EARLY DESIGN GUIDANCE OF THE EAST DESIGN REVIEW BOARD

Project Number: 3014339

Address: 605 15th Avenue East

Date of Meeting: Wednesday, April 3, 2013

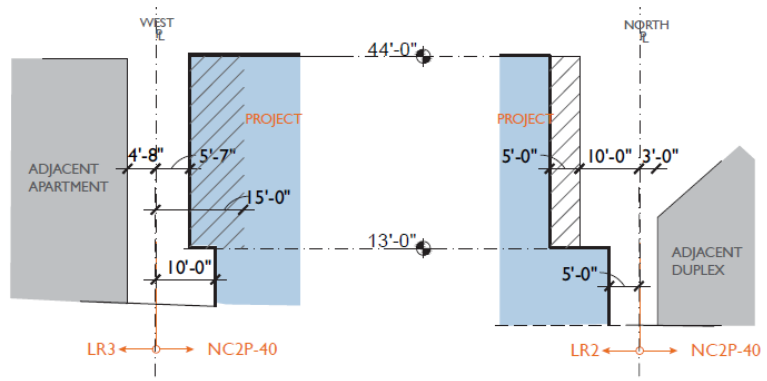
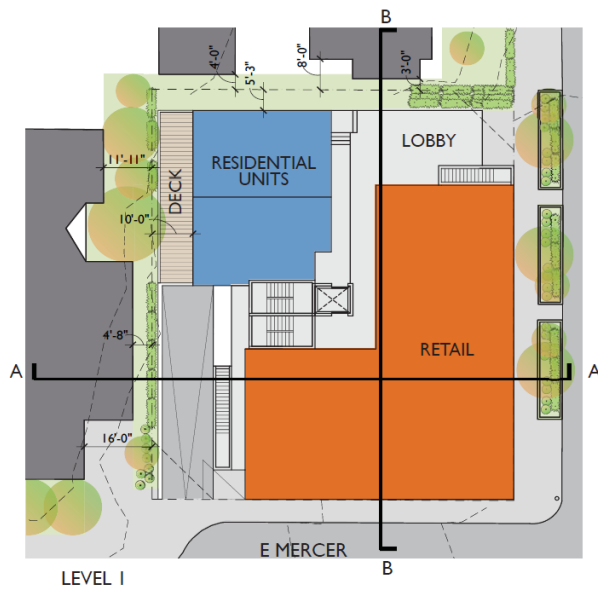
- Concerned project is not relating to the grand Capitol Hill residential architecture or neighborhood character.
- Concerned that the building to the west will have its views blocked.

- Concerned that east facing windows of the existing apartment building to the west will be blocked, and residents will lose privacy and light.
- Supported the required 15' residential setbacks being maintained.

- Stated that they liked the facade modulation of the building to west and encouraged the project to provide modulation.
- Stated that the project is not successfully transitioning to the lowrise zones.

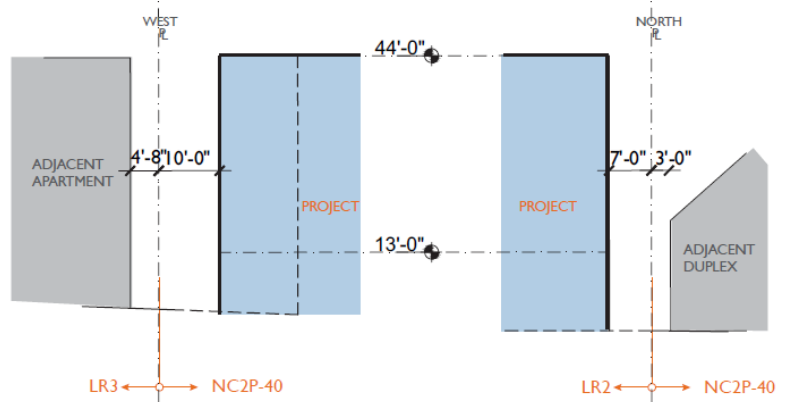
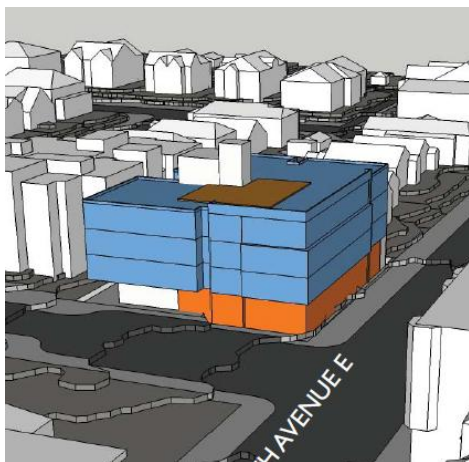
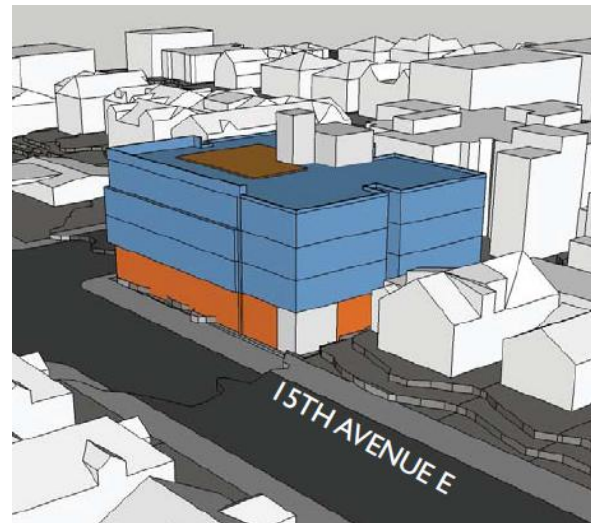
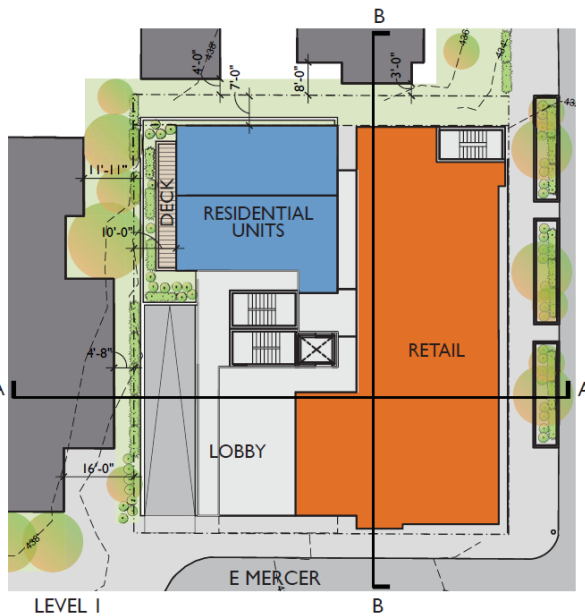
At the Early Design Guidance Meeting, the Board spent much time discussing their concern with the requested departures from the upper level residential setbacks along the north and west lot lines. They indicated that the relationship of the proposed structure should better respect the existing residential structure to the west, especially as the existing structure has balconies. The Board also discussed the relationship to the structure to the north, indicating that the proposed design seemed to show more respect for this property than the structure to the west.

The Board indicated they were not inclined to support a residential setback departure along the west property line. The Board has concerns about the residential setback departure along the north lot line but may be inclined to grant the departure if the north façade is designed well (see Guidelines C-2 and D-2). They also encouraged the applicant to consider moving the ground level closer to the north property line.

- 1. Setback requirements for lots abutting residential zones (SMC 23.47A.014.B.1):** The Code requires a 15' by 15' triangular area setback where a NC zoned lot abuts the intersection of a side and front lot line of a lot in a residential zone. The applicant is proposing a 7' setback from the north lot line.

The Board indicated that they may grant this departure depending on the responsiveness of further development of the design, including treatment of the north façade. (Guidelines A-5, B-1, C-2 and D-2)

- 2. Setback requirements for lots abutting residential zones (SMC 23.47A.014.B.3.a&b):** The Code requires structures along a rear or side lot line that abuts a residential zoned lot to be setback 15' for portions of the structure above 13' in height up to 40', and an additional 2' for every ten feet of height above 40'. The applicant proposes a 7' setback along the north lot line.

The Board indicated that they may grant this departure depending on the responsiveness of further development of the design, including treatment of the north façade. (Guidelines A-5, B-1, C-2 and D-2)

- 3. Setback requirements for lots abutting residential zones (SMC 23.47A.014.B1):** The Code requires a 15' by 15' triangular area setback where a NC zoned lot abuts the intersection of a side and front lot line of a lot in a residential zone. The applicant is proposing a 5' setback at the upper stories from the west lot line.

The Board indicated that they are concerned about this departure and are unlikely to support such a departure, due to the potential loss of privacy and light to the development to the west. (Guidelines A-5 and B-1)

- 4. Setback requirements for lots abutting residential zones (SMC 23.47A.014.B.3.a&b):** The Code requires structures along a rear or side lot line that abuts a residential zoned lot to be setback 15' for portions of the structure above 13' in height up to 40', and an addition 2' for every ten feet of height above 40'. The applicant proposes a 5' setback for the southern portion of the structure along the west lot line and a 10' setback for the northern portion of the structure along the west lot line.

The Board indicated that they are concerned about this departure and are unlikely to support such a departure, due to the potential loss of privacy and light to the development to the west. (Guidelines A-5 and B-1)

- 5. Driveways (SMC 23.54.030. D.3):** The Code requires that no portion of a driveway exceed a slope of 15%. The applicant is requesting a driveway with a maximum slope of 20%.

The Board is inclined to support this departure, provided that safe circulation can be shown. (Guideline D-7)

The Board stated that the applicant should move forward with a design closer to the code compliant option.
